Date: 5th November 2021
Reference: 9200-3 Rev 1

RE: Fitzalan Link Road, Littlehampton – Noise Review

WYG Report 2016

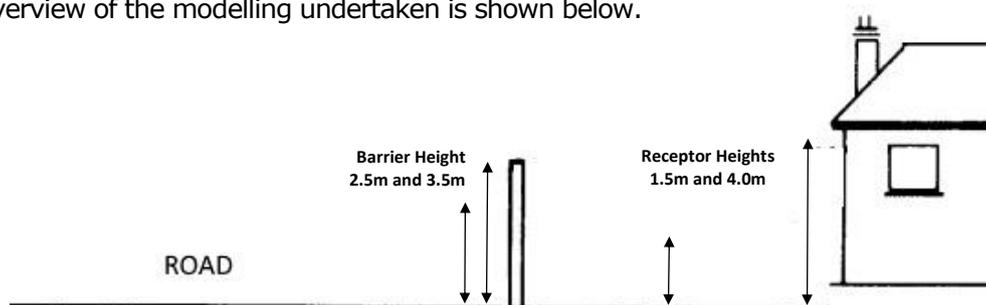
- 3.1 A review of the RM report July 2016 shows that the input traffic flow data (18 Hr AAWT) appears to be broadly consistent with those recently received by 24 Acoustics from West Sussex CC (via email 29th September 2021). There are certain subsets of data (eg, %HGVs, porous road surface) that have not been stated. Although implied only from the 2017 update note, it is assumed that an operational traffic speed of 30 mph applies in the 2016 report. The model appears to have used a hybrid CRTN/ISO 9613 approach and a German standard for ground absorption, which is not consistent with the requirements of DMRB. The reasons for this approach are not clear.

- 3.2 This report, in line with the requirements of the Calculation of Road Traffic Noise (CRTN), predicts noise levels at a height of 4m. No noise predictions were made at ground height (1.5m) in response to the EHO's queries to assess the impact in gardens. The report, after Table 5.3, also directly compares the modelled $L_{A10\ 18\ hour}$ values at a height of 4m with the $L_{Aeq\ 16\ hour}$ criteria (at a height of 1.5m) in BS 8233 which is incorrect (the 2017 assessment also repeats this comparison). The study should have contained calculated levels at 1.5m height (ie, representing standing height in a garden) to address the EHO's query. No night-time values were calculated and this is considered to be an omission, given the potential impact to first floor bedrooms.

- 3.3 The report includes a reference to a 2.5m barrier in Drawing SK02b on Page 31; this appears to be a typographical error as all other references are to a 3.5m noise barrier.

- 3.4 Fundamentally, the alignment of the barrier in SK02b of the noise report (see Appendix C) is materially different to the approved plans (and as constructed). It follows that the predicted receptor noise levels are not likely to be representative of the barrier in its current / approved location.

- 3.5 Given that the modelling in the noise report deviates significantly from the approved plans, it is considered that none of the work undertaken is of practical use to demonstrate the impact of the Fitzalan Link Road. The uncertainties mean that a comparative or relative noise assessment which looks at the change in noise level cannot reliably be undertaken.

- 3.6 In summary, it is 24 Acoustics' opinion that the methodology and findings of the WYG study were not sufficient for a reasonable conclusion to be drawn by decision makers at ADC.

FIGURE 1A – SCHEME OVERVIEW

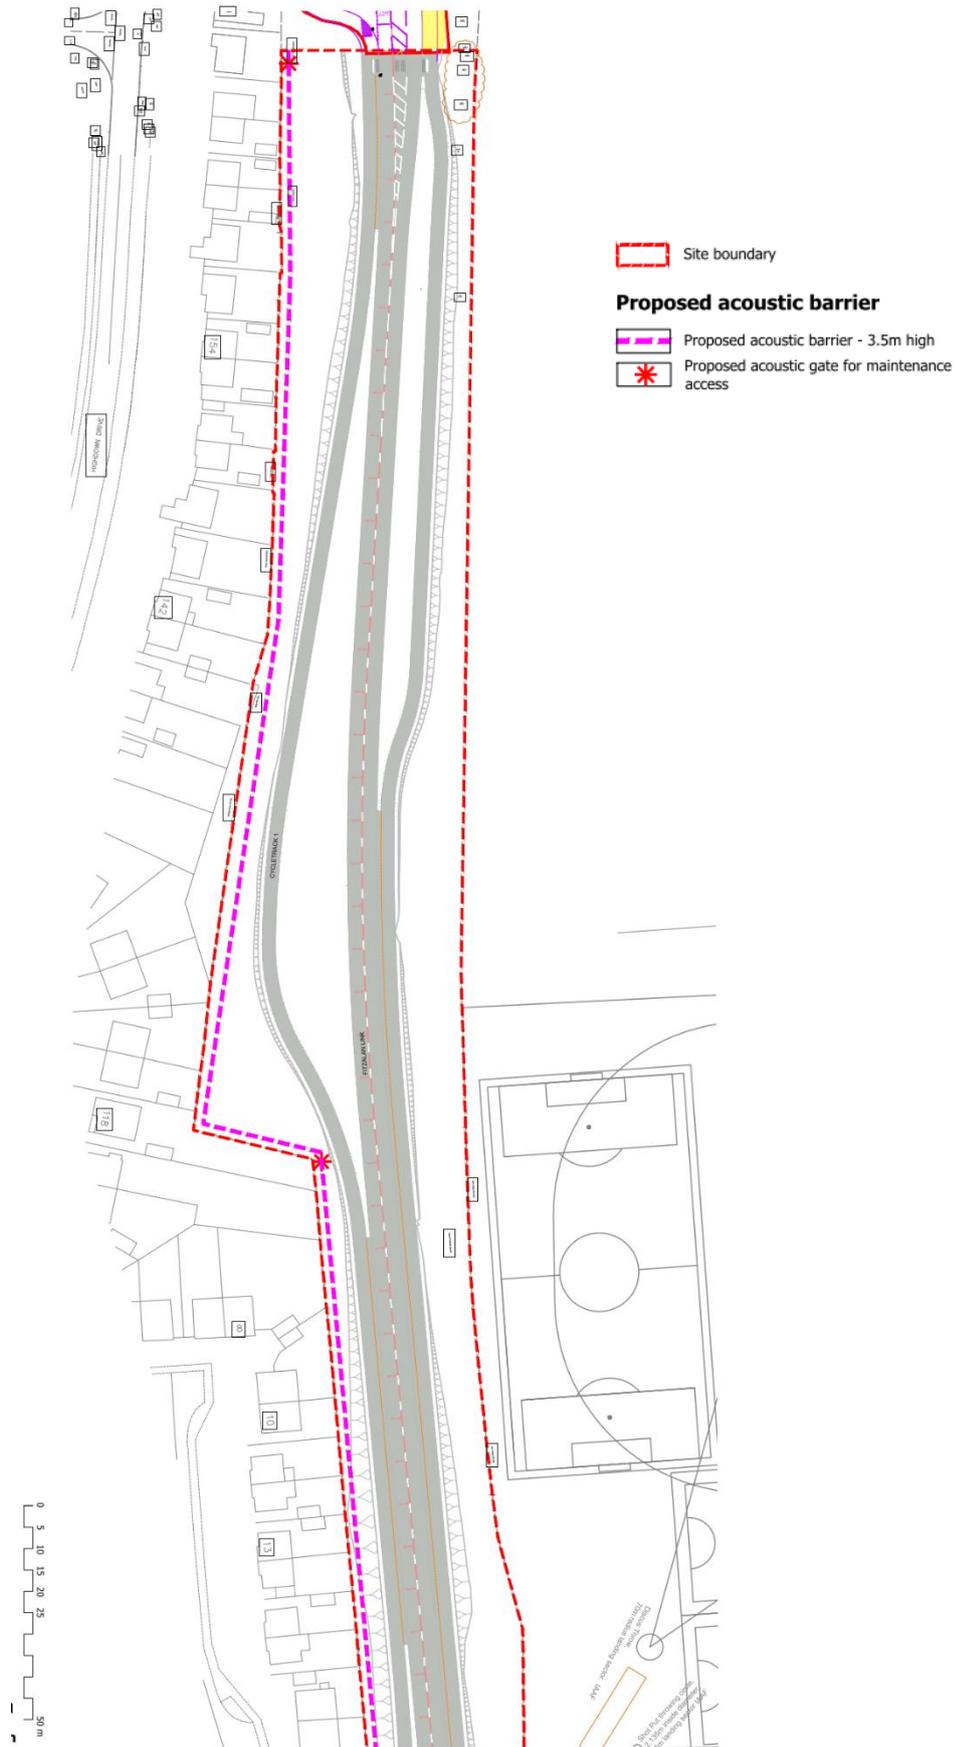
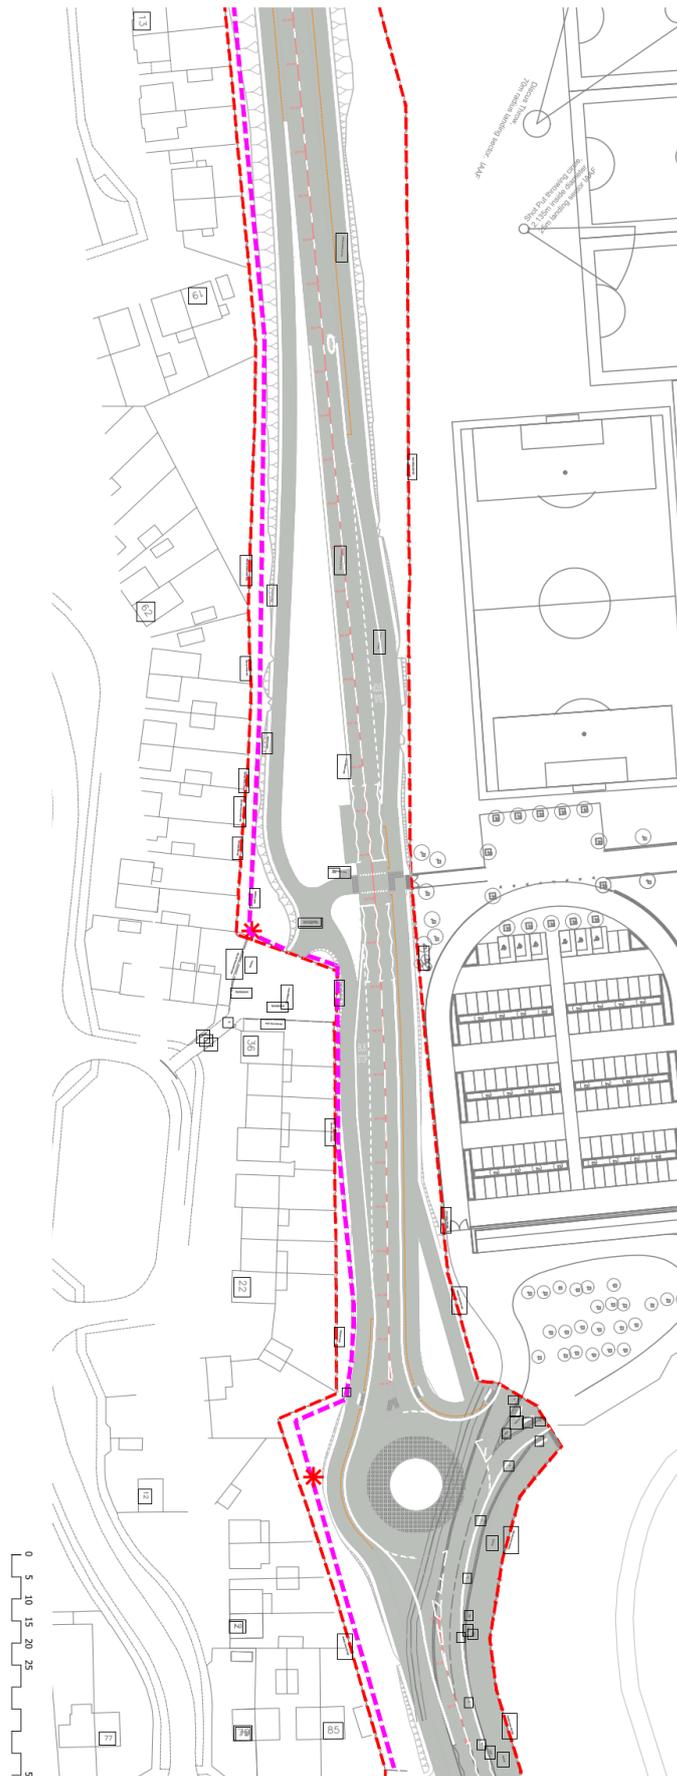
- 1.10 The road scheme, barrier and surrounding area is shown in Figures 1A and 1B. For reference, the term noise barrier may be used interchangeably with acoustic screen or acoustic barrier. It should be noted that light-weight close boarded timber fences are usually of insufficient weight and quality to be considered as a robust form of noise mitigation for new road schemes.
